California High-Speed Train Project

Agreement No.: HSR 13-06
Book 3, Part D, Subpart 5

Design Variance Report

DESIGN VARIANCE COVER SHEET

ASHLAN AVE - EXHIBIT 9

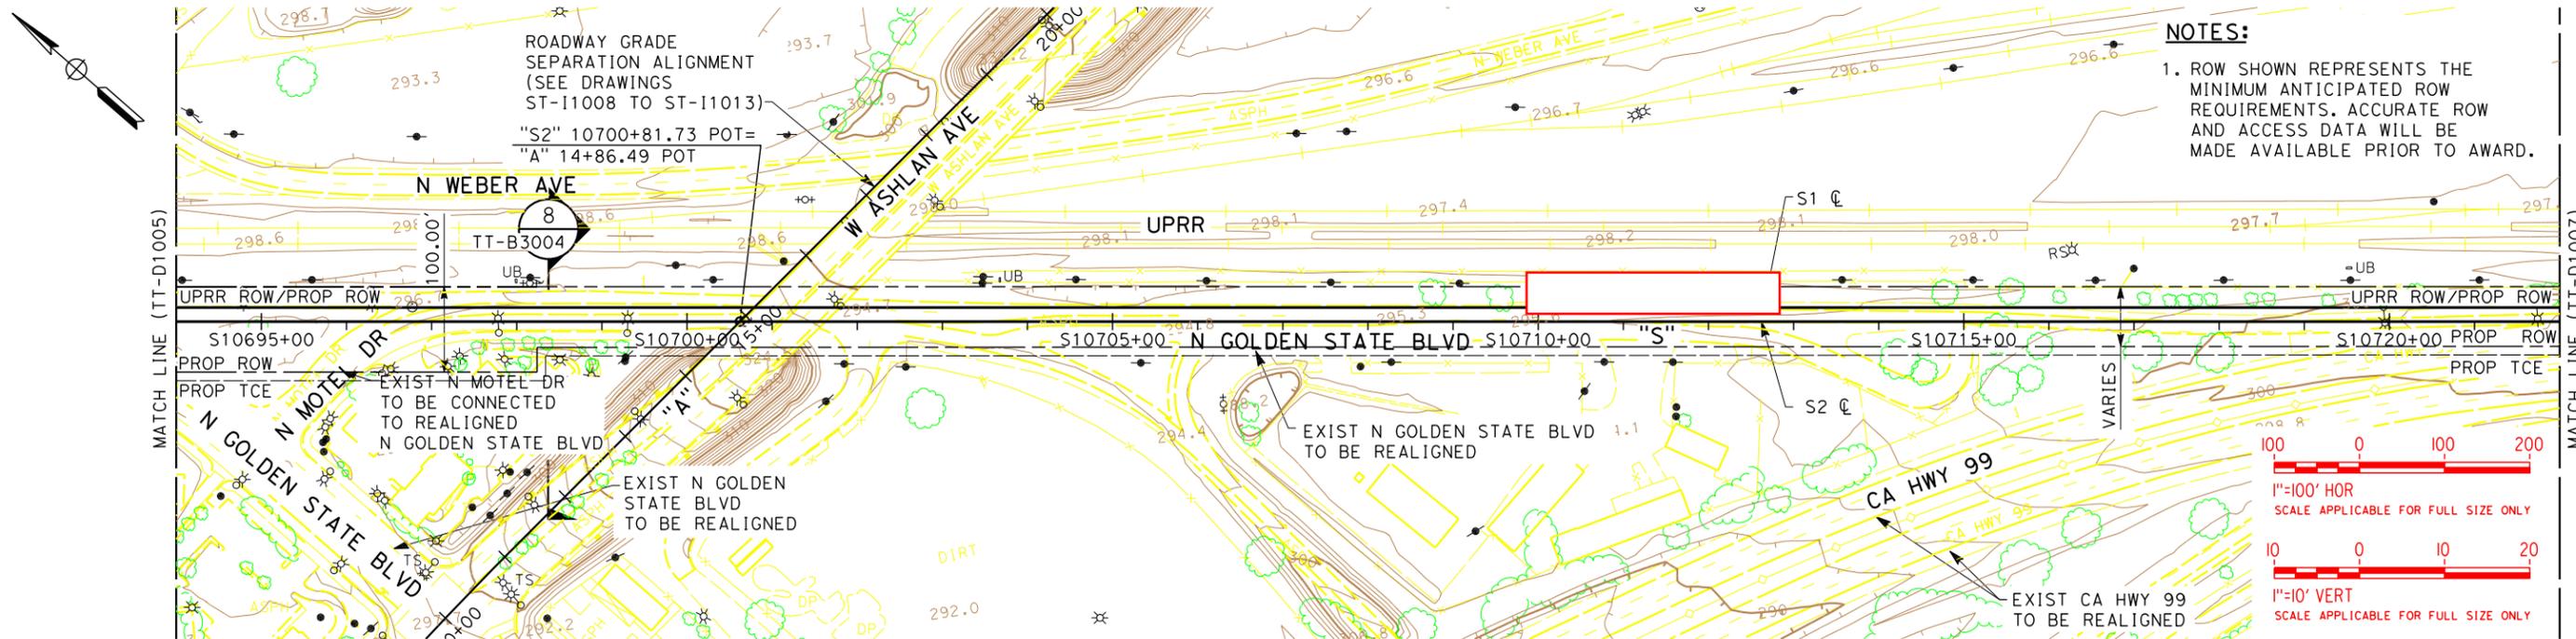
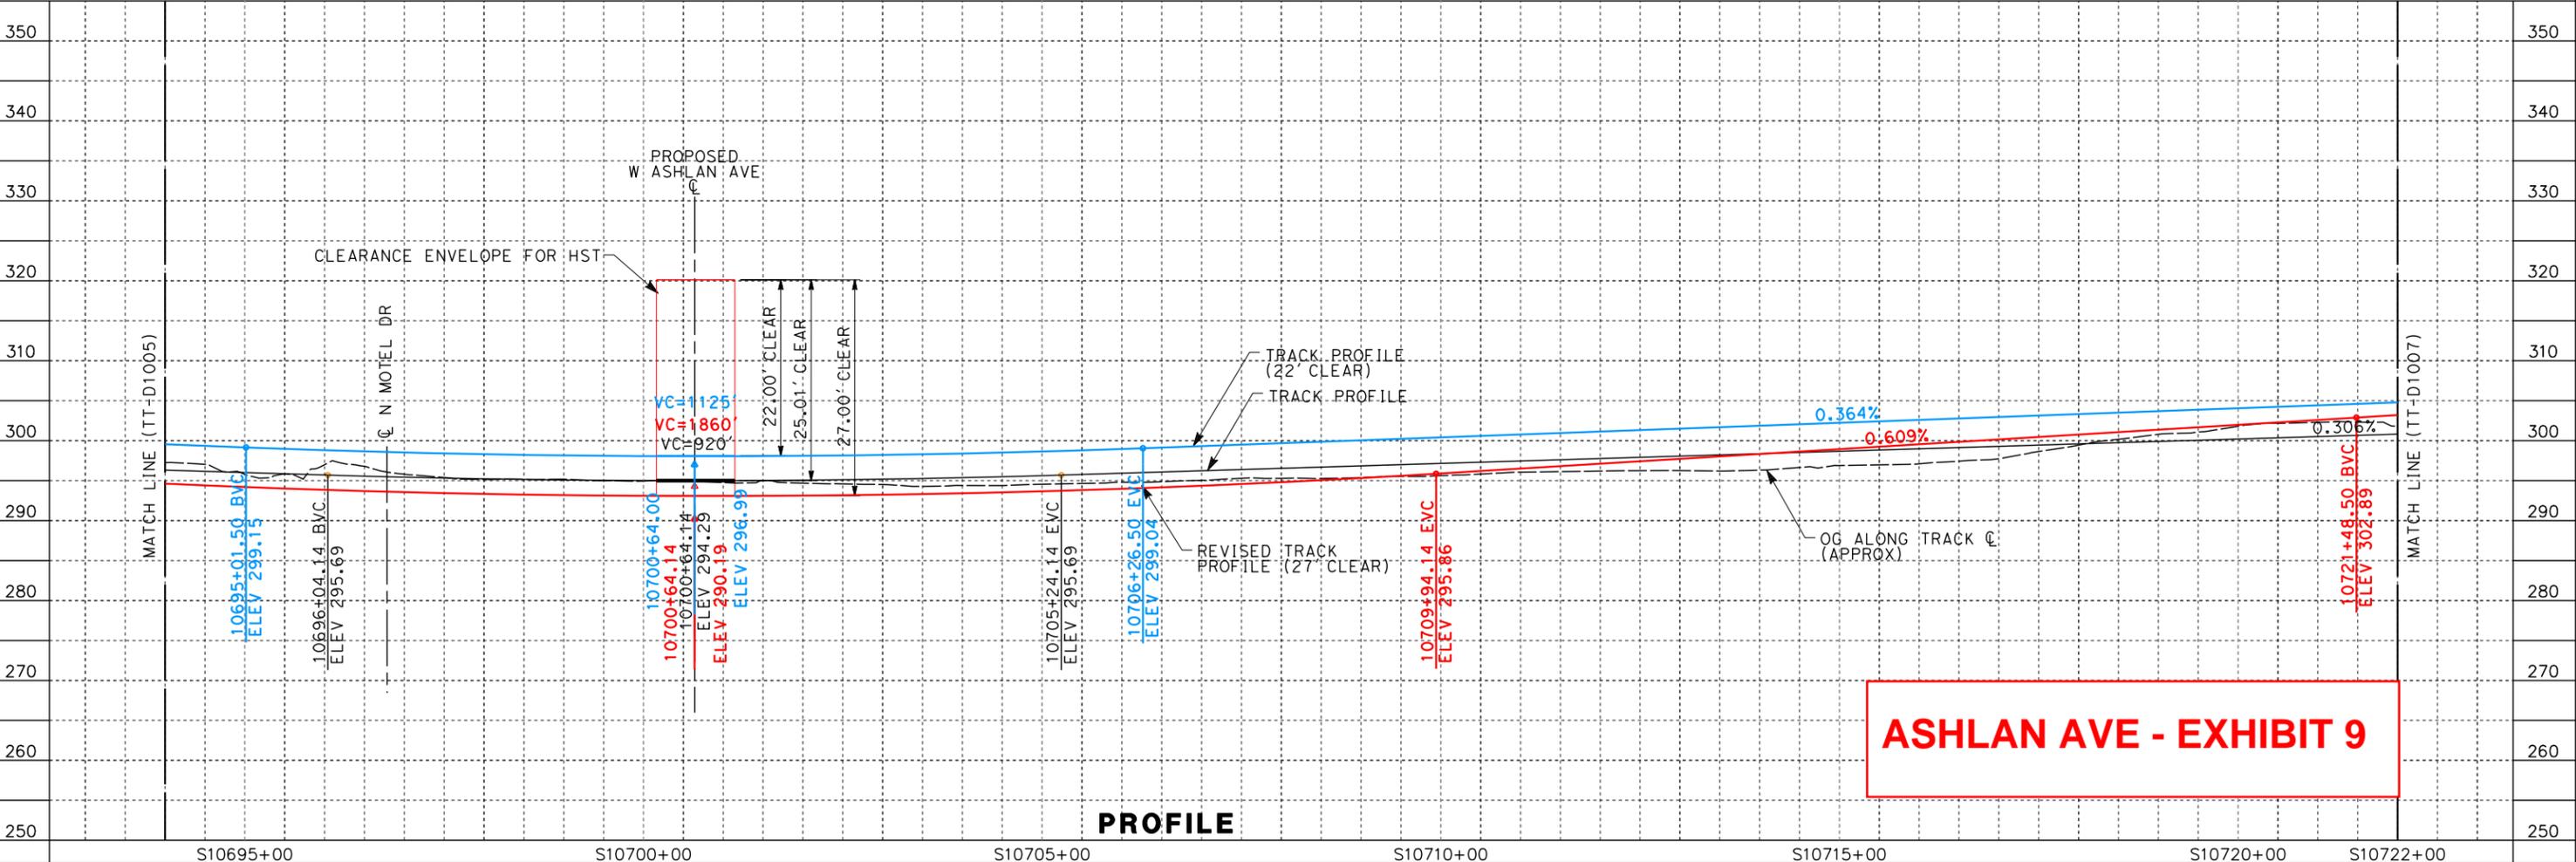
As a basis of comparison, the draft final 30% design of HSR profile was further refined to examine conditions which can increase clearance under the new Ashlan Ave structure from to standard 27 ft. As shown in calculations in Exhibit 8, and profile design plan in Exhibit 9 (Red line), this condition will result in TOR at lower elevation than the required elevation of 298 ft to clear estimated flood conditions (TOR 293 ft). In fact, TOR under this condition will be 2 ft below existing ground elevation (2.5 ft below estimated flood elevation). To provide flood protection a 2500 long wall/boat section, 5 ft deep will be required. Additionally since the lowered HST TOR and drainage system is now lower than the existing grounds, feasibility of draining HST into nearby facilities will have to be re-examined. Lowered drainage outlet may require pump station to elevate drained storm water above the local drainage inlets and basins.

PROPOSED ALTERNATIVE DESIGN REQUIREMENT	Allow minimum clearance under replacement bridge to be 22 to 24ft , this equates to TM 3.2.1 Directive Drawing for existing bridges up to 120 ft wide with free running OCS and reduced System Depth. Use Up to 2 ft of Walls/boat section for flood protection Or Allow deeper track work construction below flood elevation, while protected by a boat-section and pump station may be needed

Clinton Avenue - Exhibit 4

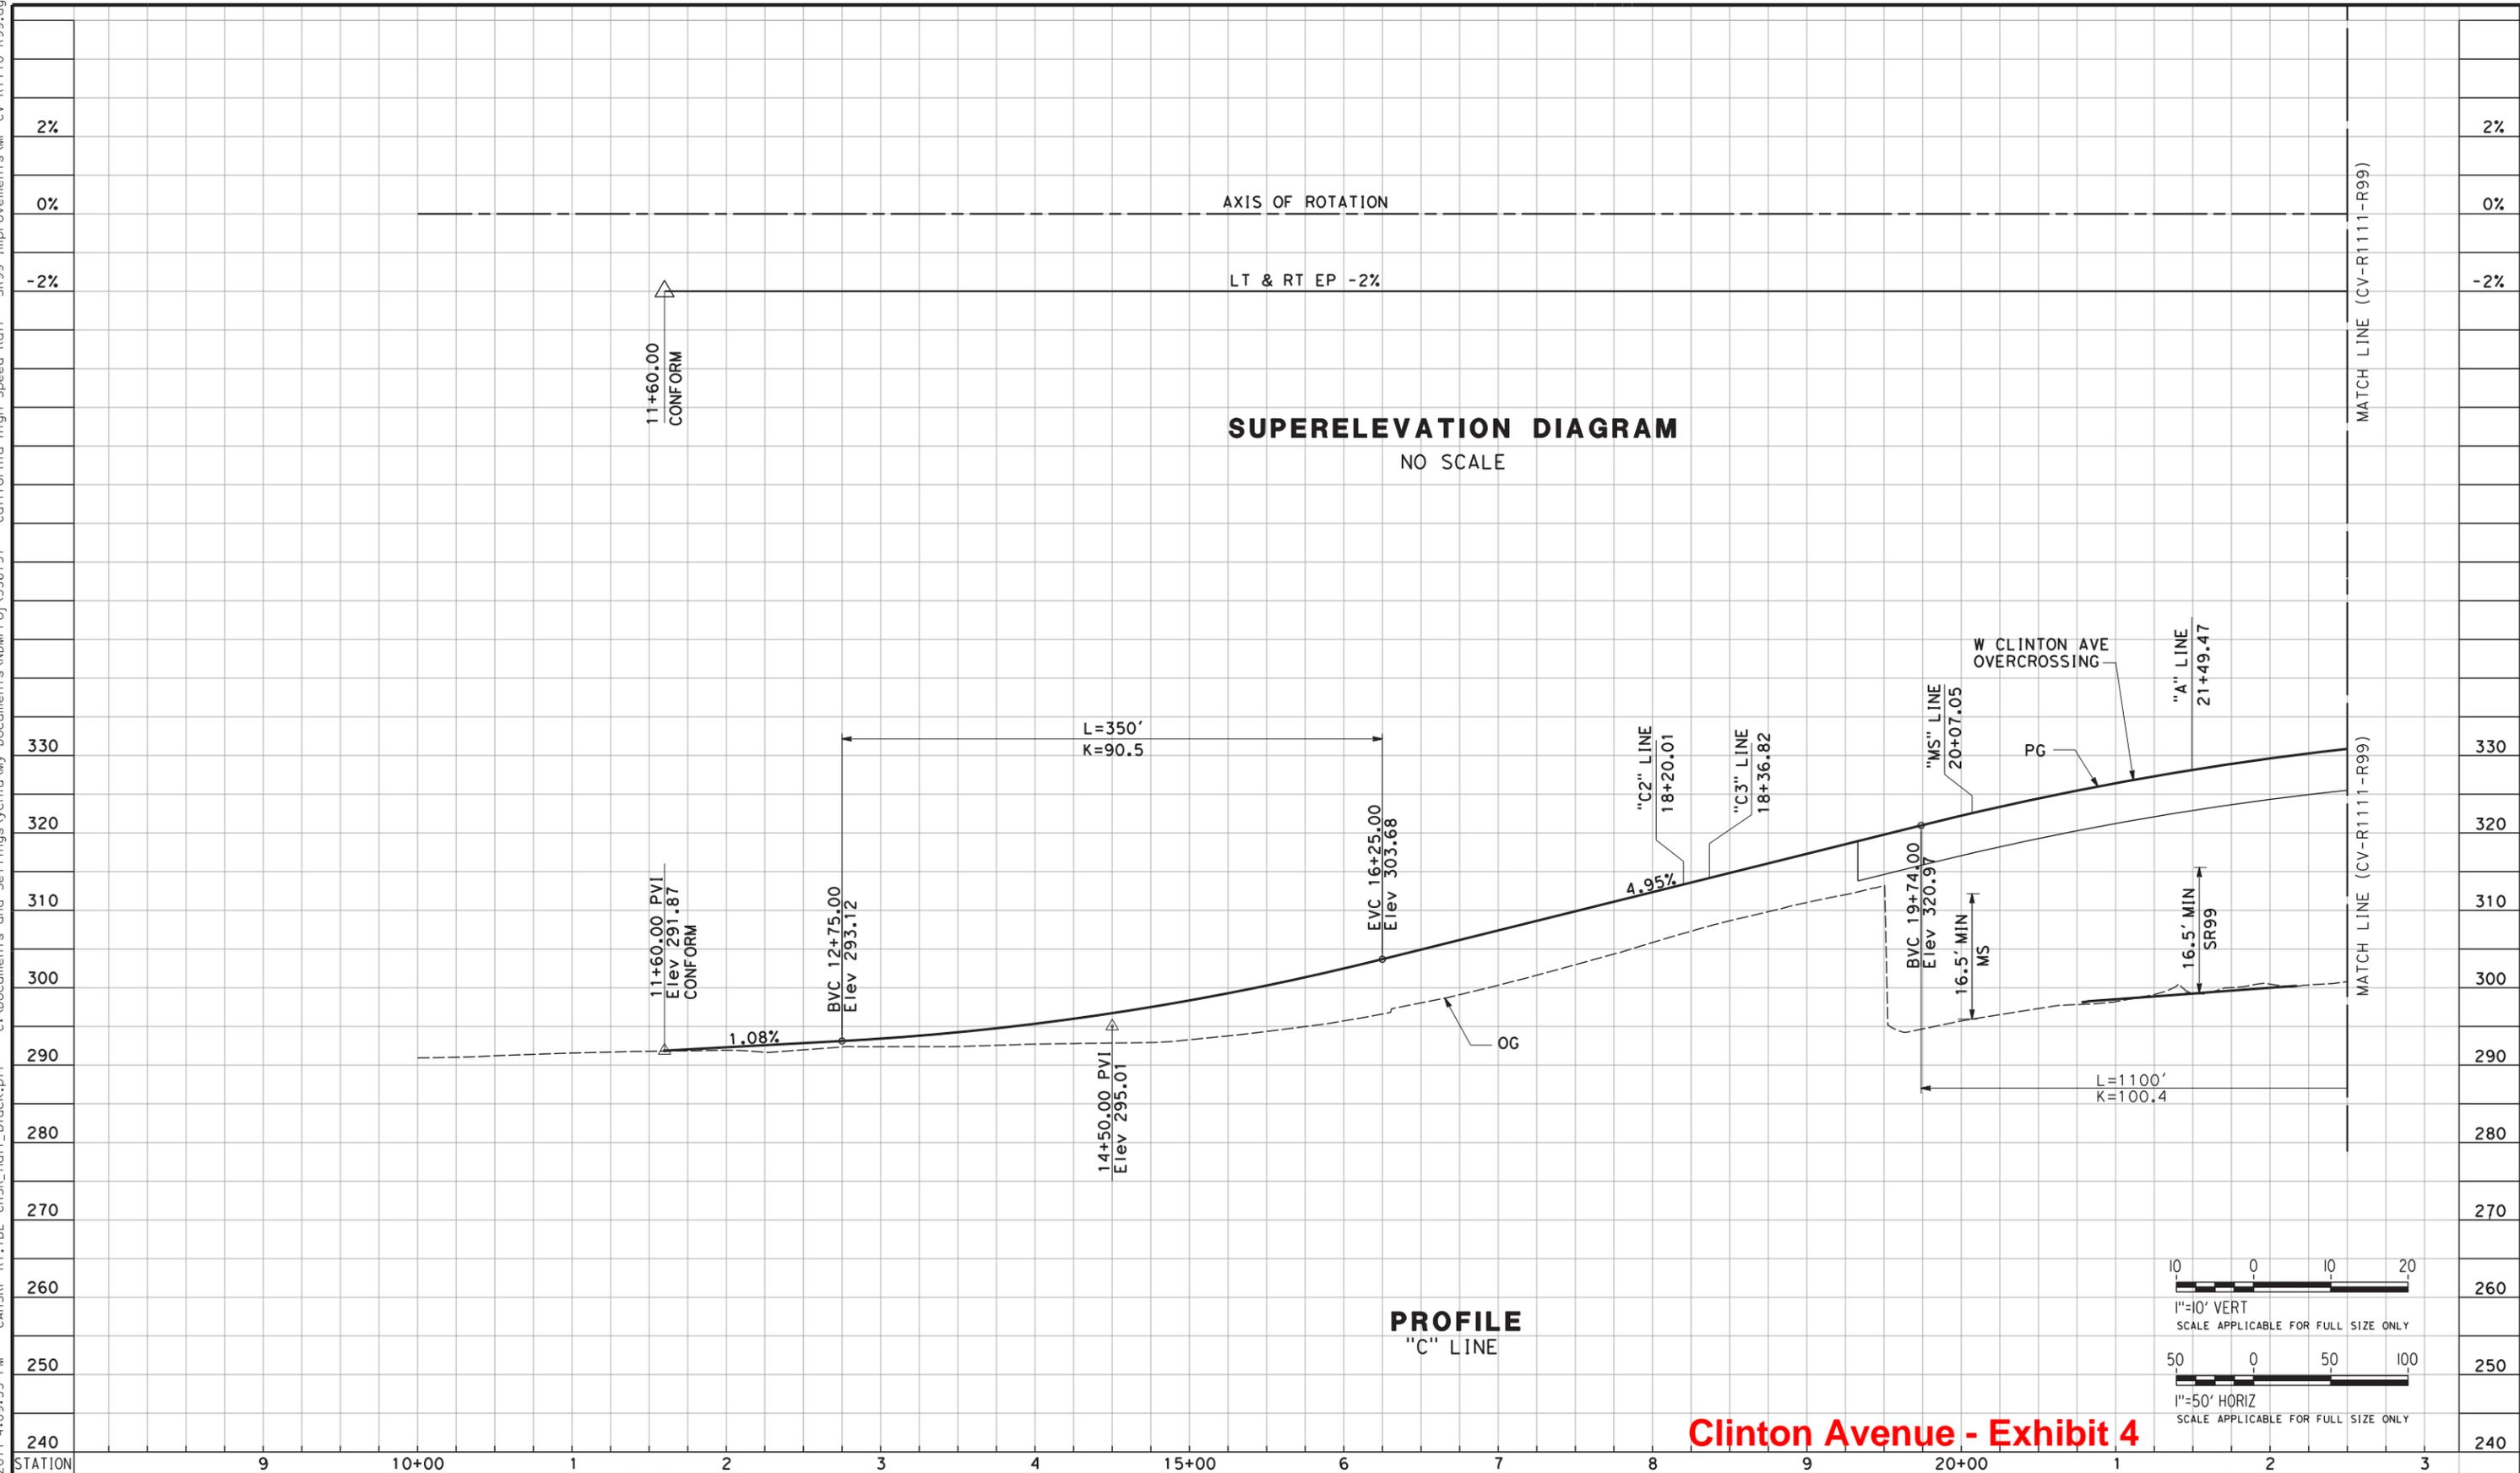
<p>used to meet the flood elevation requirements.</p> <p>Current draft 30% roadway design, as shown in Exhibit 4 is based on current mapping. It should be noted that as a result of the poor accuracy of the initial mapping (+/- 3 ft accuracy), lower clearance was discovered when using the updated mapping. The current draft 30% design has already adjusted the roadway profile and HST profile to provide additional 1 ft clearance due to the initial mapping accuracy issues.</p> <p>Subsequent evaluation and adjustment of the 30% profile design were conducted based on :</p> <ul style="list-style-type: none"> • Updated mapping (+/- 0.5 ft accuracy) • Estimated flood elevation requirement <p>Based on FEMA evaluations and maps, 100 year flood event will impact regions near San Joaquin River, Herndon Canal and south of Clinton. <u>Local area adjacent to Clinton Ave. is therefore subject to only localized flooding for which flood agencies use 6 inch water elevation above existing ground/Golden State Blvd..</u> At Clinton crossing, existing ground is at 297.5 ft. Allowing for 0.5 flood elevation (i.e. elevation 298), TOR at 2.5 ft higher will be at minimum elevation of 300.5 ft.</p> <p><u>A track profile with 24 ft clearance below the Clinton overhead structure, will meet flood elevation requirements with no need for boat section.</u></p> <p><u>C-DVR 25.5 ft clearance, w/ 1.5 ft deep Wall/Boat Section</u></p> <p>The draft 30% HST track profile design shown in Exhibit 4, provides for an intermediate option of 1.5 ft higher 25.5 ft clearance over HSR tracks, by lowering the profile.</p> <p><u>The estimated flood elevation will impact the current 30% design with the DVR 25.5 ft clearance condition, requiring a 1.5 ft wall/boat section.</u></p> <p>As shown in exhibit 7, the draft 30% design HST profile (in black) will have TOR below minimum 300.5 ft level to clear flood elevation requirement, for nearly 1000 ft North of Clinton. This is primarily due to the HST profile adjustment required due to the initial mapping accuracy/errors. To meet flood elevation clearance requirements, it is proposed to consider wall/boat-section to protect track work</p>
